City of Portland, Oregon
Bureau of Development Services
Land Use Services

MEMORANDUM

Date: October 5, 2012
To: Guy Bryant, GPB Construction Inc.
From: Dave Skilton, Development Review
Phone number 503-823-0660
Re: 12-175067 DA
Summary of Design Advice Meeting - September 24, 2012

Summary of Advice from the Historic Landmarks Commission, provided at the September 24, 2012 meeting, regarding EA 12-175067 DA.

SITE & LANDSCAPE PLAN

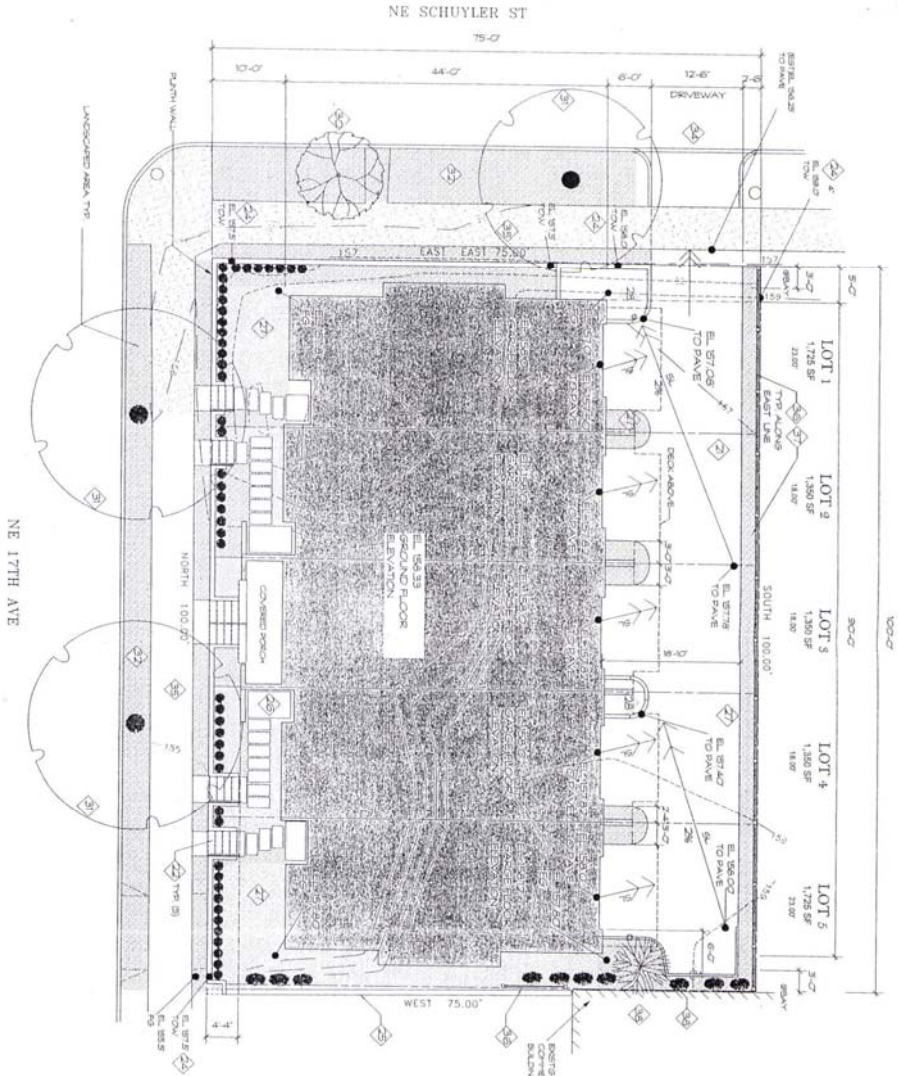
It was noted that detailed information on proposed lighting fixtures and their locations will be required for the final submission, as well as information on fences, retaining walls, plantings, driving and walking surfaces, etc.

Driveway/Parking: In addition to comments during its discussion of materials, see above, the Commission requested that the design of the drive aisle and the detailing of its boundary and

surrounding landscape conditions be given careful consideration. The purpose is to soften the impact of a relatively large area of paving that will be visible from the right of way. The relationship among the drive aisle width, the wing wall depth, and the width of the garage doors will also need to be worked out to make vehicular maneuvering efficient. This may require garage doors somewhat wider than proposed at the design advice meeting. They will need to be well integrated into the overall composition of the rear elevation, as will the privacy walls between the upper level decks.

ELEVATION WEST

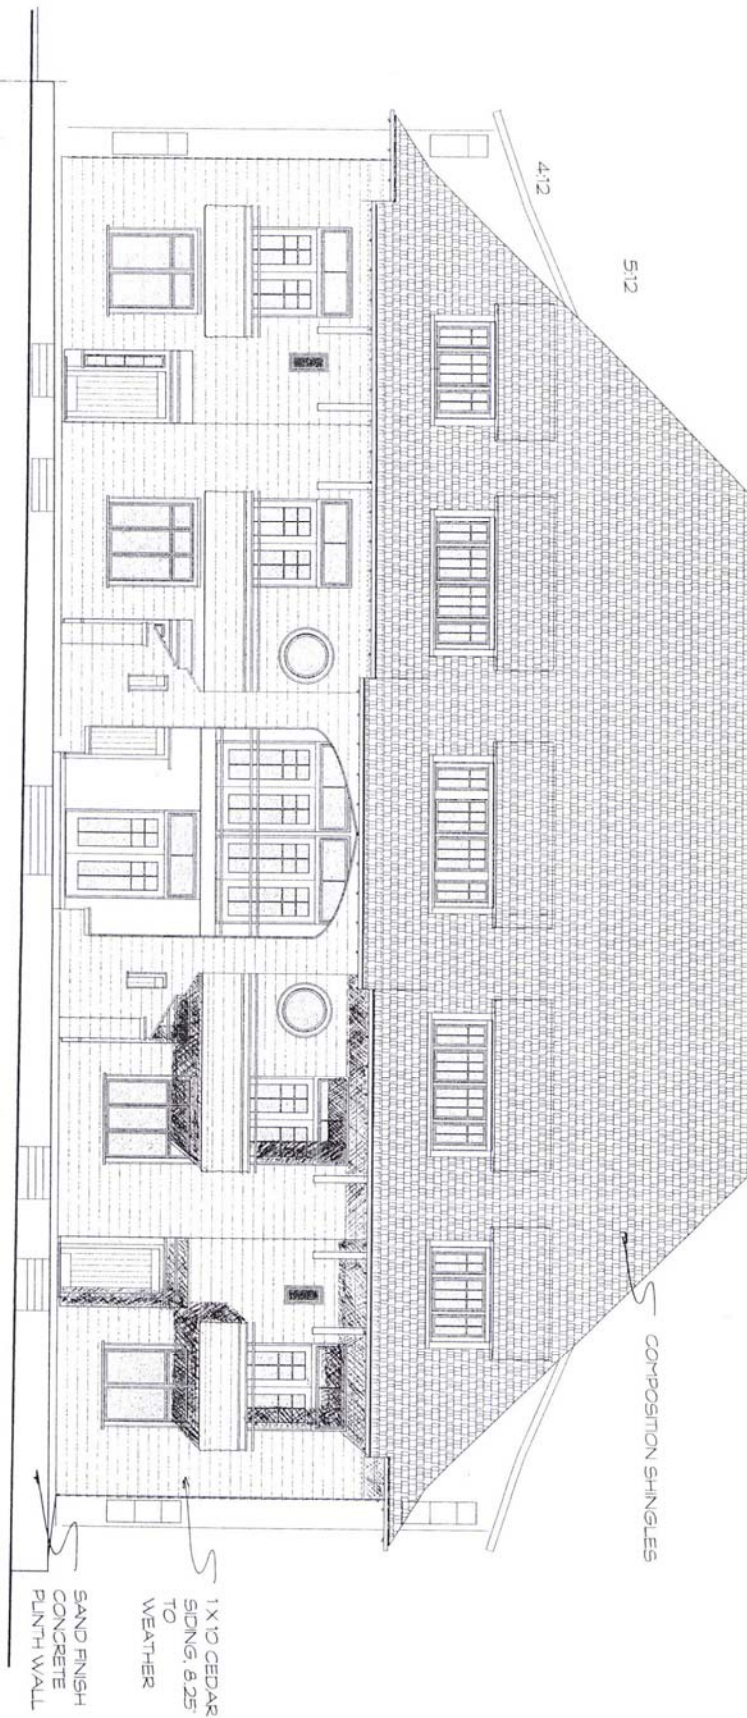
The idea of using painted cedar siding was well received. Most commissioners, however, criticized the number of window and transom types and railing treatments as contributing to a lack of overall cohesiveness, and especially to a disparity between the east and west facades. The applicant was encouraged to limit the palette of window types and sizes, achieving variety through combinations rather than differences, and to treat similar elements, such as balconies, the same on all sides of the building.

ELEVATION NORTH - SOUTH SIMILAR

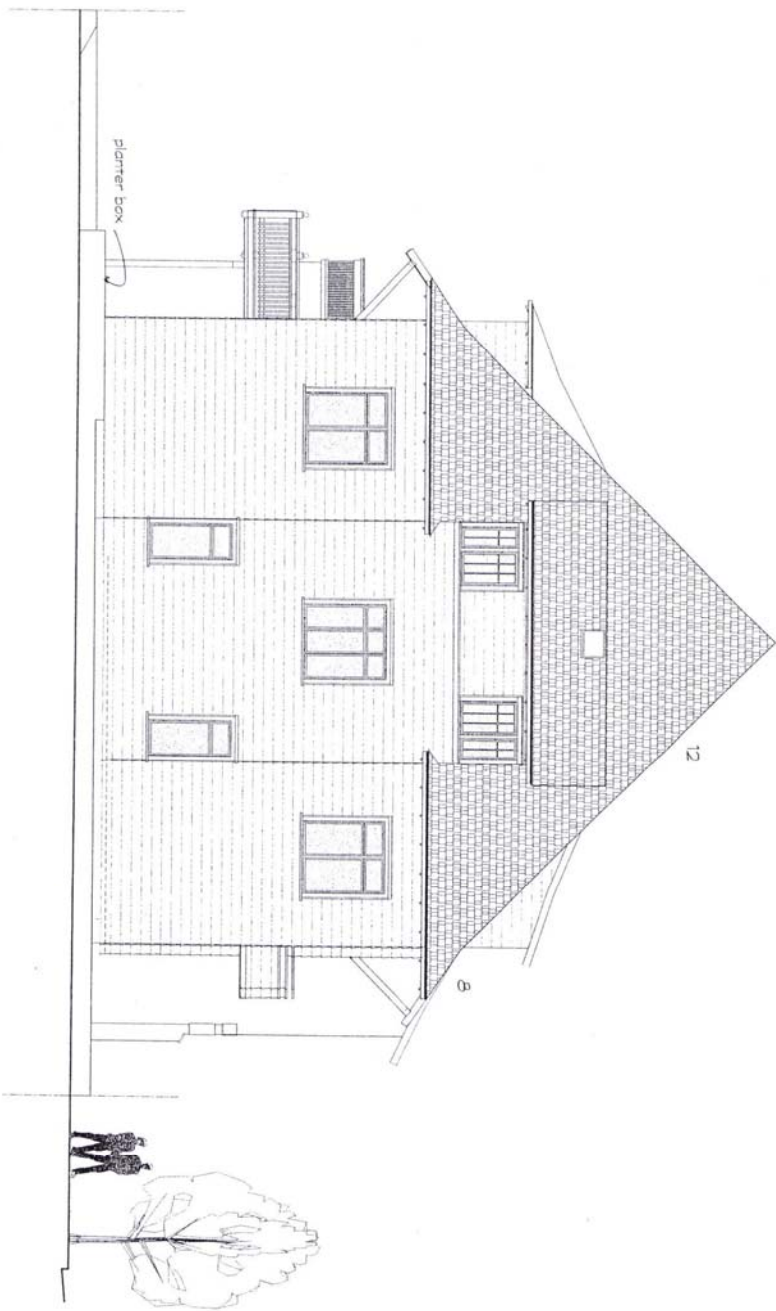
Massing and Scale: While the "big move" of a dominating roof form received support, there was also skepticism that the apparent height as defined by the eave datum would sufficiently mitigate for its actual height as proposed. Commissioners urged the applicant to study the proposal further in perspective and asked that future drawings and renderings at least depict accurate building outlines on nearby properties for comparison. Suggestions for lowering the overall roof height included reducing the pitch or truncating the proposed hipped structure. Another strategy suggested for decreasing the impact was to set the building further back from NE 17th Avenue. With reference to the six sketch elevation schemes presented, those identified as "E" and "D" were most often cited as appropriate models, especially because of the strength of their central facade elements. Several commissioners commented that the hybrid bay/dormer elements centered on the north and south facades should be studied further and treated either as true dormers or preferably as protruding bays with roof forms more like that of the main building volume. It was also suggested that a similar treatment, i.e. a more prominent roof form could appropriately strengthen the central "main entry" element on the NE 17th Avenue facade.
